Proposed New Entrance to UAF at Geist and Loftus Road

Subject: MPC Recommendations Related to the DOT's Proposed New Entrance to UAF at Geist and Loftus Road

DOT Proposed Roadway Locations

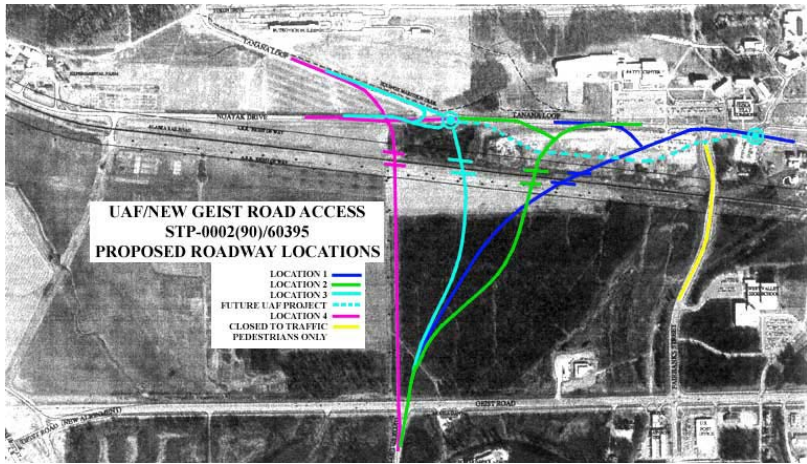
Of the DOT's proposed options for a new entrance from the intersection of Geist and Loftus Road, the MPC sees no option of worth other than that identified as Location 3 (light blue line) in diagram UAF/New Geist Road Access, STP-0002(90)/60395 used at the Public Open House on November 19, 1998. [MPC recommendation "Loftus 1/15/99/2"]
